**RE: Ascension Subdivision
Revised Drainage Report and Revised Grading Plan
Engineer's Stamp Date: 08/09/19
Hydrology File: B17D006**

DATE: Aug 9, 2019
TO: COA Hydrology
FROM: Kelly Klein, PE and Mike Balaskovits, PE
SUBJECT: Amendment to "Drainage Report for Ascension Subdivision"
dated 1-21-19

The purpose of this amendment to the Drainage Report for Ascension Subdivision is to amend the flow direction of Basin 6 in *Exhibit C- Amended Basin Map From DMP* and add the corresponding Offsite Basin 2 in *Exhibit D- Developed Conditions Basin Map*.

PROFILE VIEW: PV - (22)
ALG: SD alignment for HGLview
HORZ. SCALE: 1"=50'
VERT. EXAG.: 5
VERT. SCALE: 1"=10'

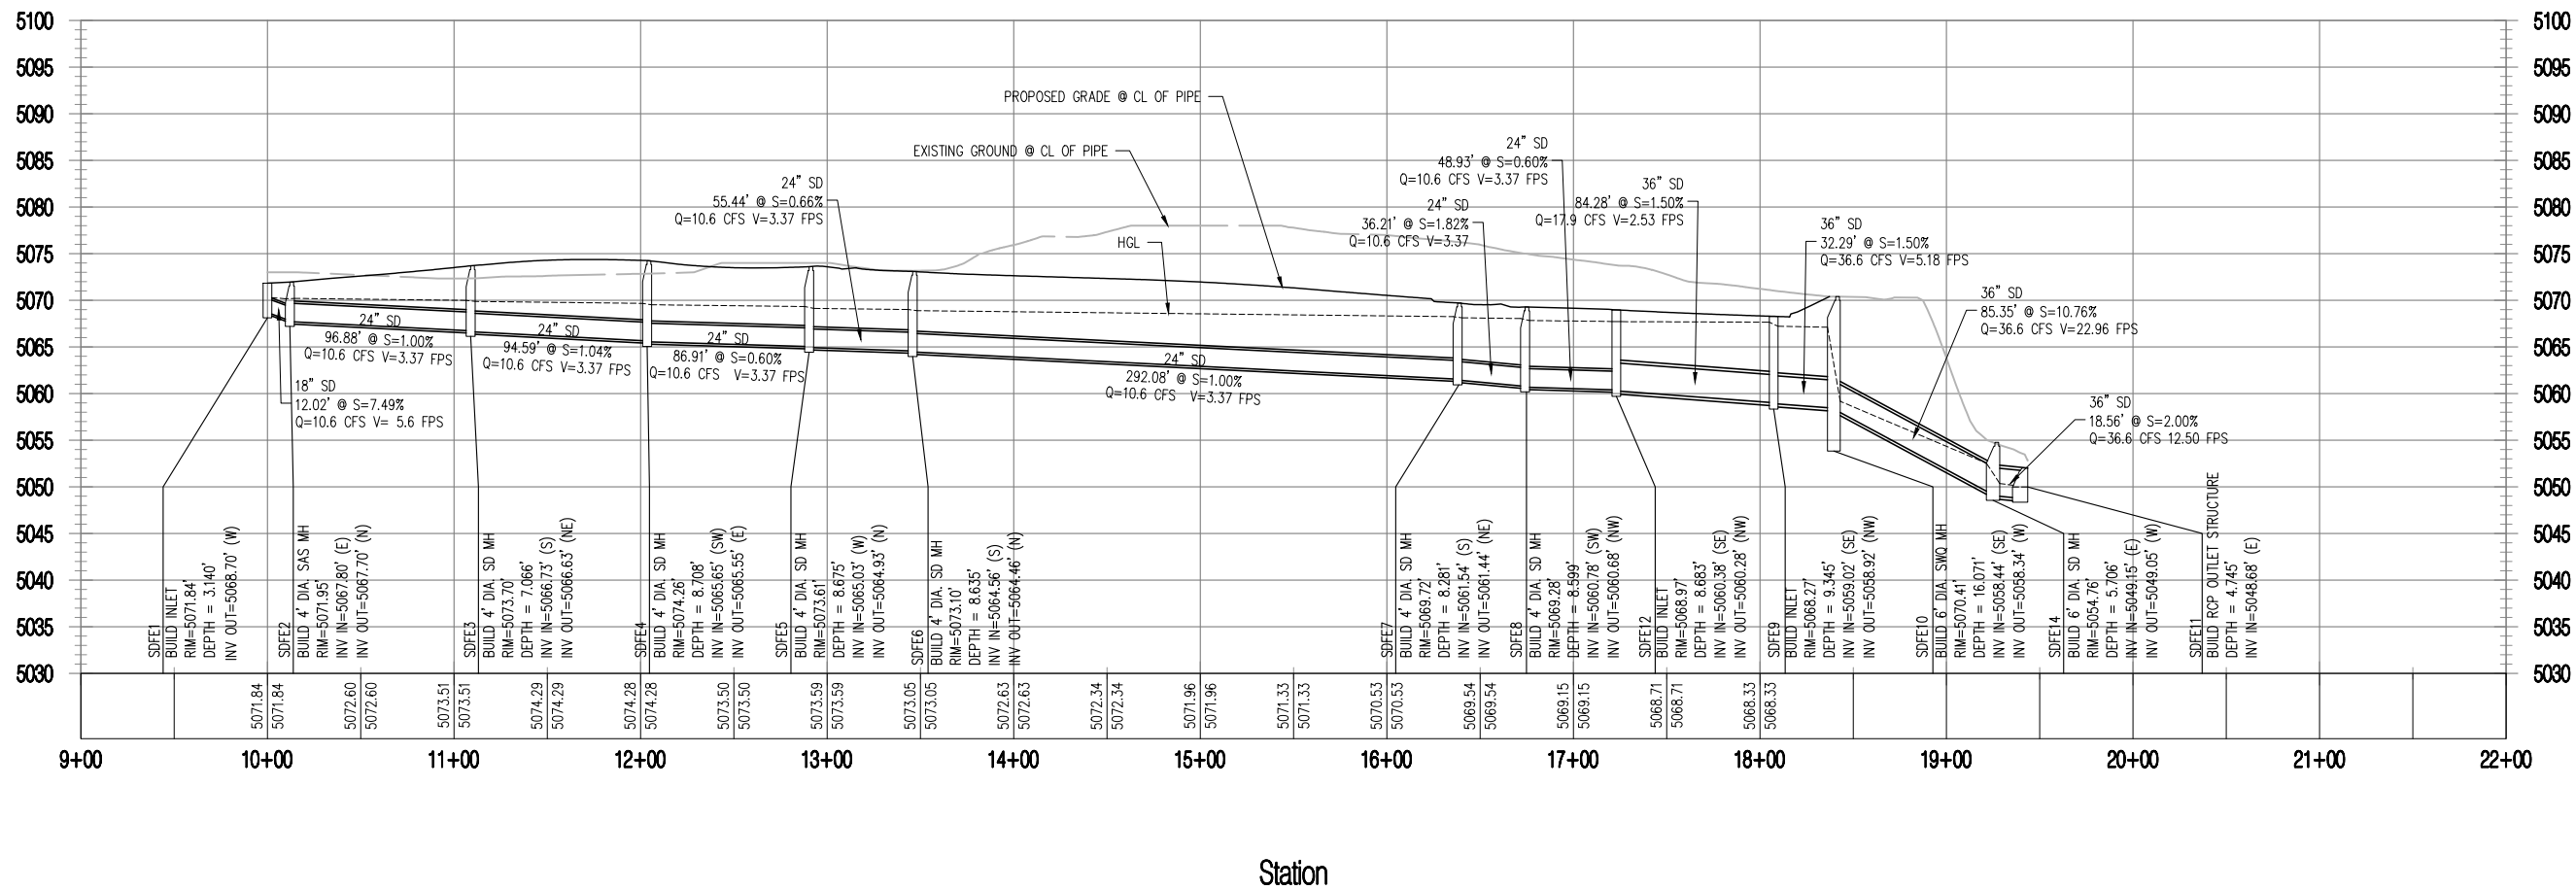
APPENDIX B – STREET HYDRAULICS AND STORM DRAIN INLET ANALYSIS
Pages 22-26: Revised HGL Calculations and Profile

East Easement Swale

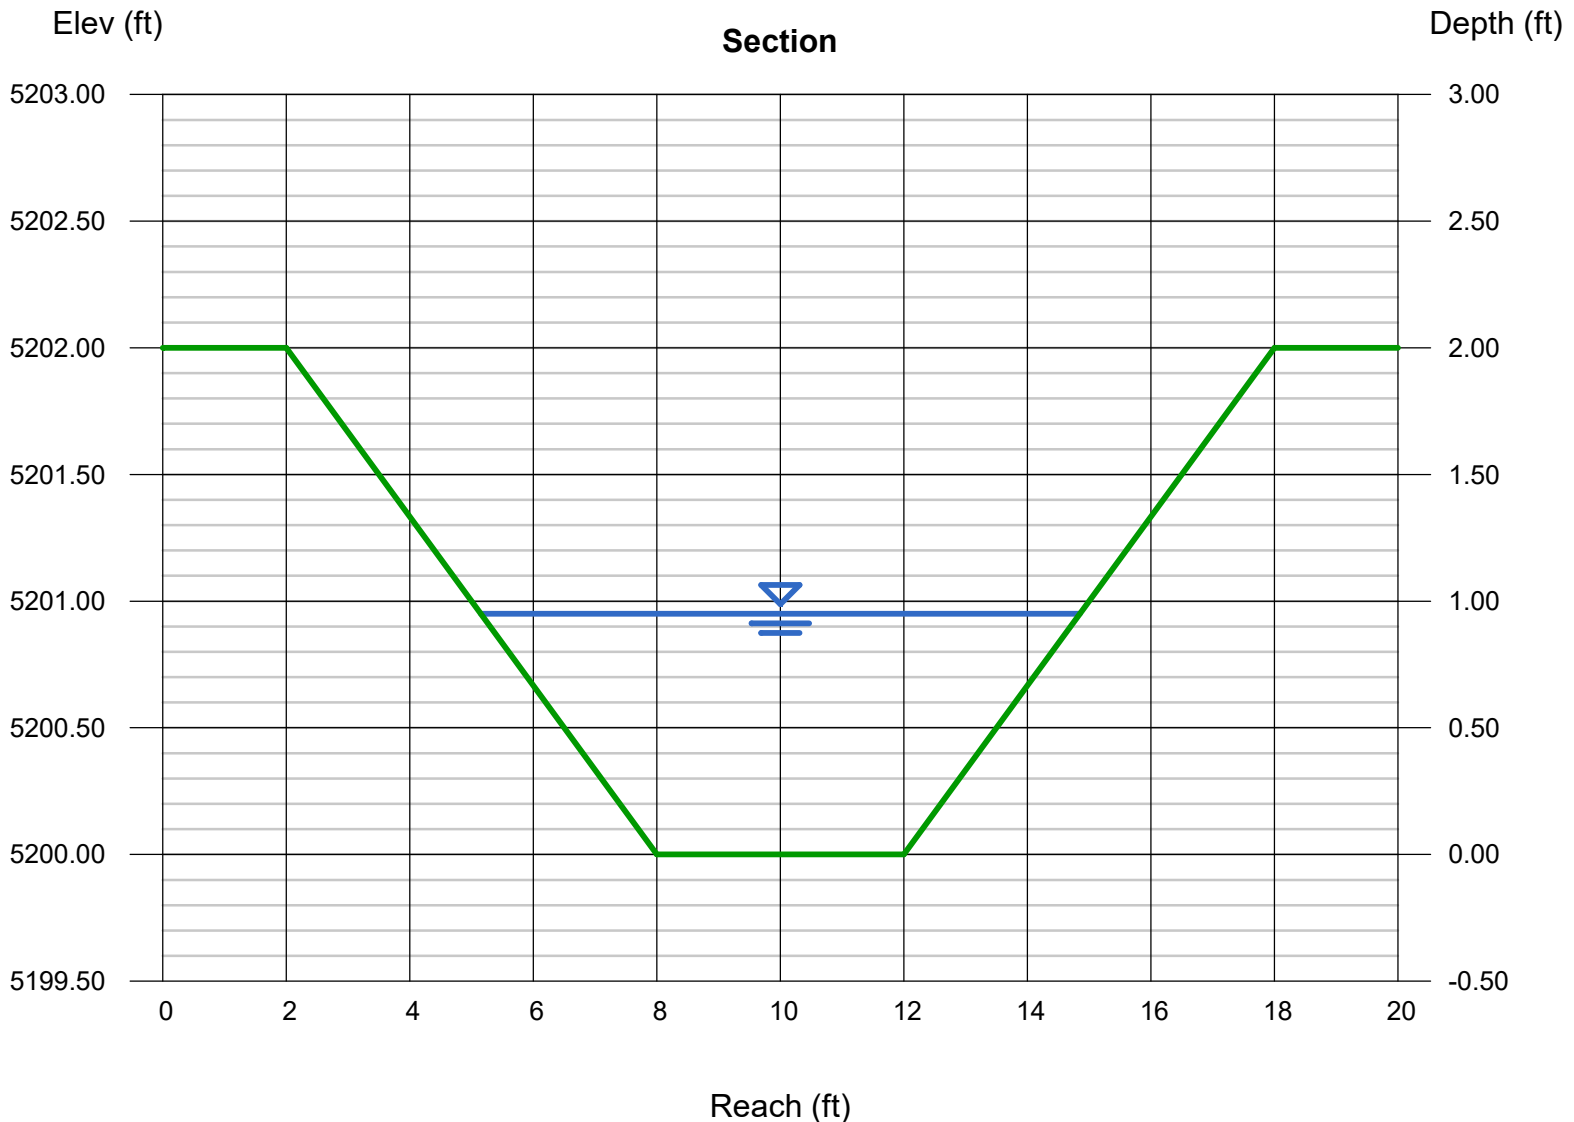
The offsite portion of FPCCDMP Basin 6 (Tract 3B-2-A), south of Ascension, currently drains east and discharges into the southeastern corner of Ascension Subdivision. A new swale (sized to accommodate 19.4 cfs) along the east edge of the Ascension Subdivision property conveys the flow from this offsite Basin 6 to Basin 10 as it historically does today.

APPENDIX C – EAST SWALE CAPACITY

**EXHIBIT C -
AMENDED BASIN MAP FROM DMP**

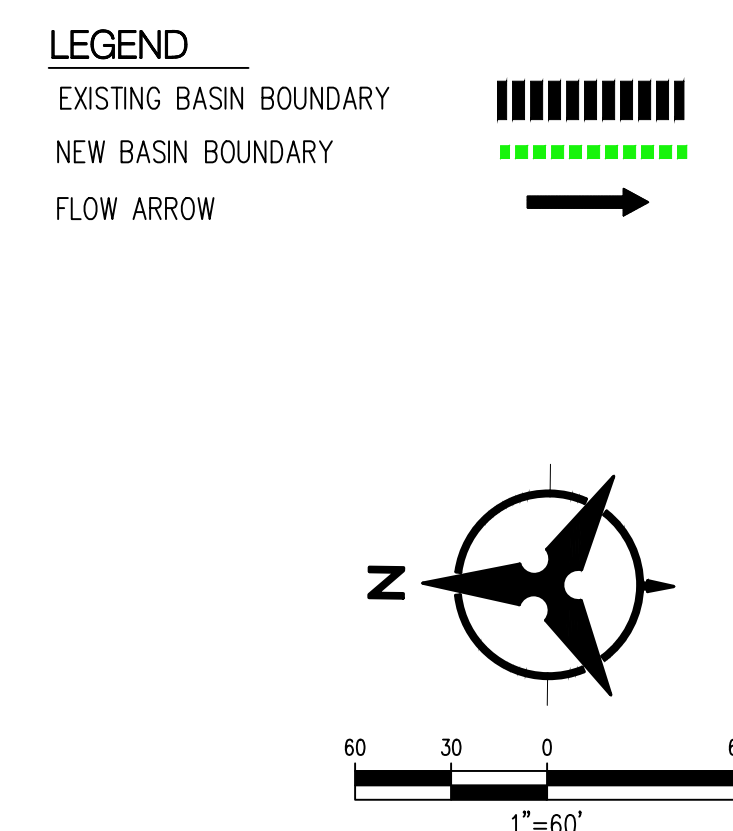
"However, the offsite portion of FPCCDMP Basin 6 (Tract 3B-2-A), south of Ascension, currently drains east to Balloon Fiesta Park. A swale along the west edge of the Balloon Fiesta property conveys the flow from this portion of Basin 6 to Basin 10. This drainage pattern for the southern portion of Basin 6 will not change with the Ascension development."

**EXHIBIT D -
DEVELOPED CONDITIONS BASIN MAP**

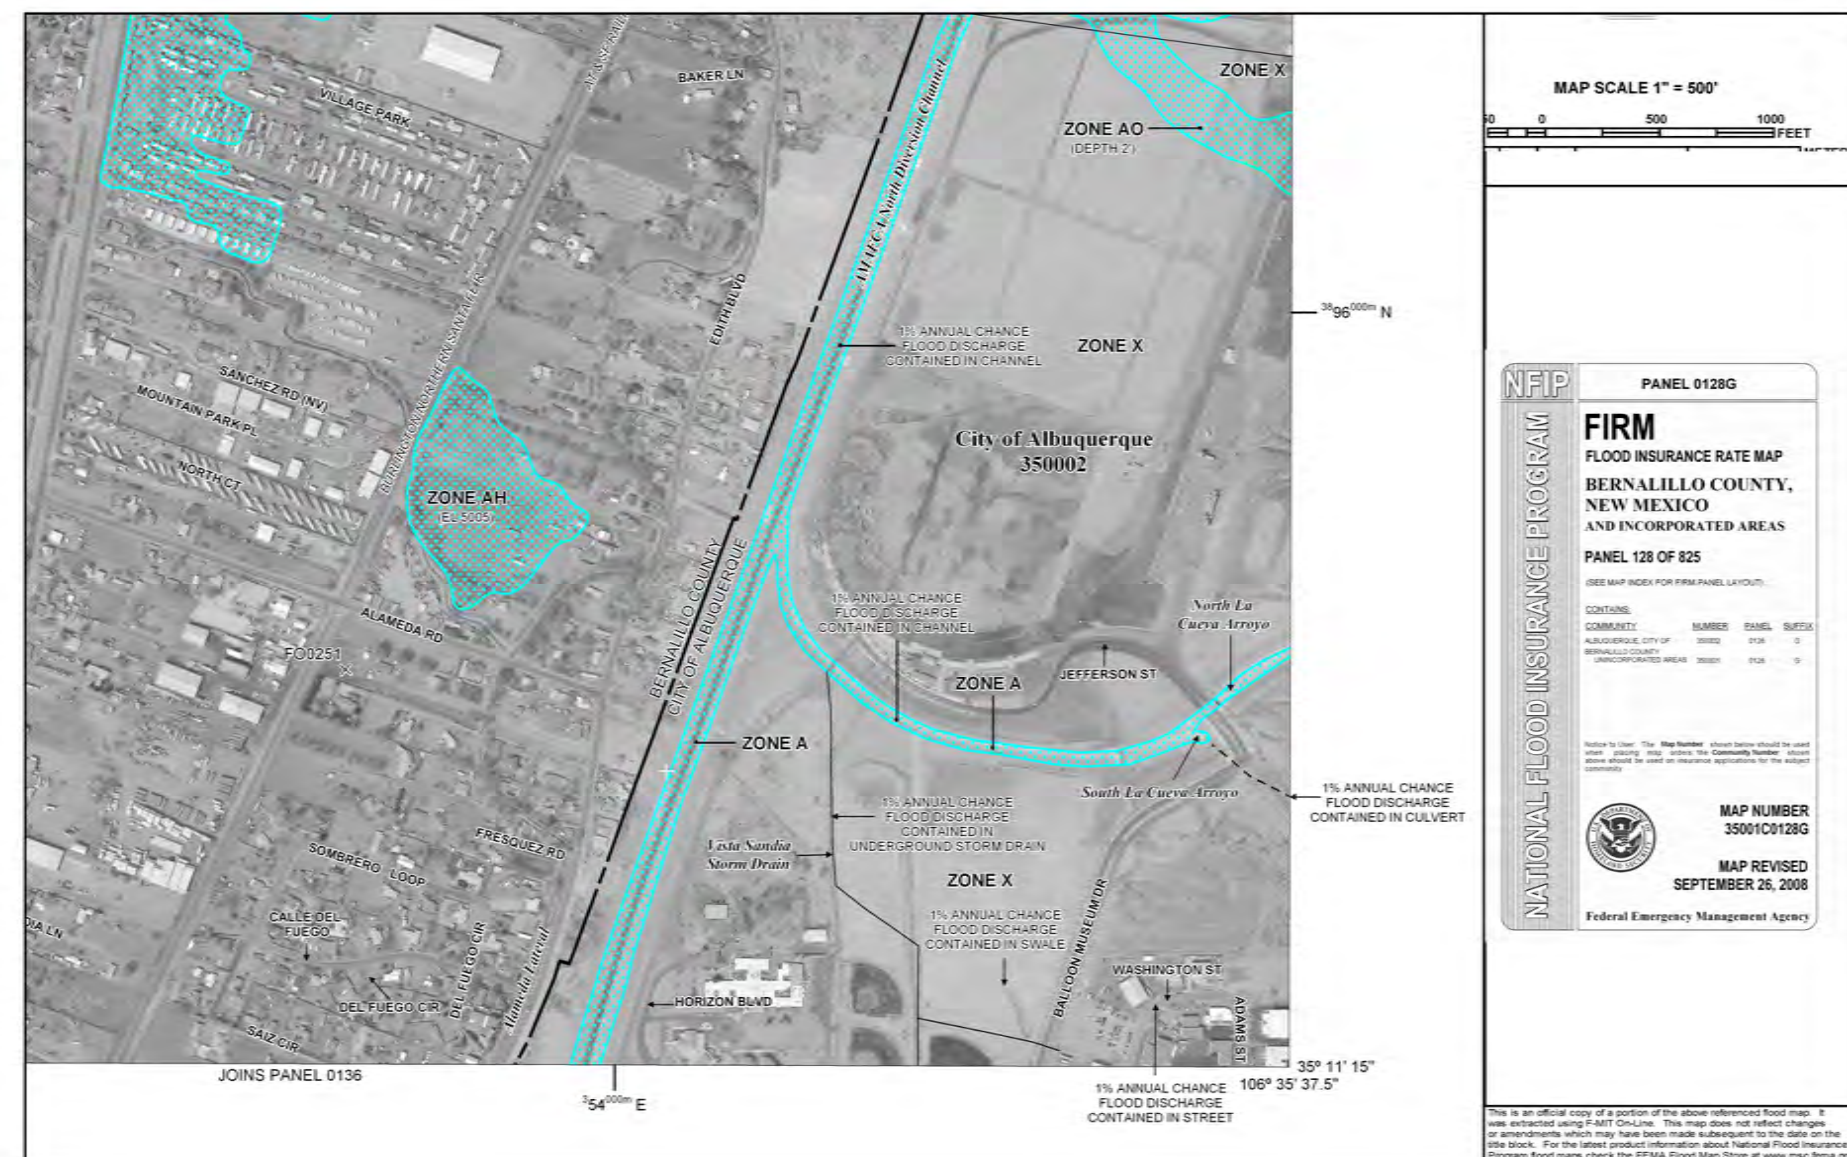
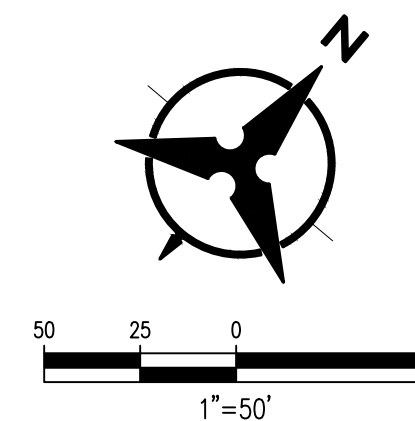
The site has been divided into three basins in the developed conditions; Basin DEV-1, DEV-2, Basin DEV-2a. Basin DEV-2a will serve as a surface private drainage easement to allow the flows from OFFSITE Basin 2 to pass through the site to Basin 10 per the amended Fiesta Park Care Center Drainage Master Plan (FPCCDMP).
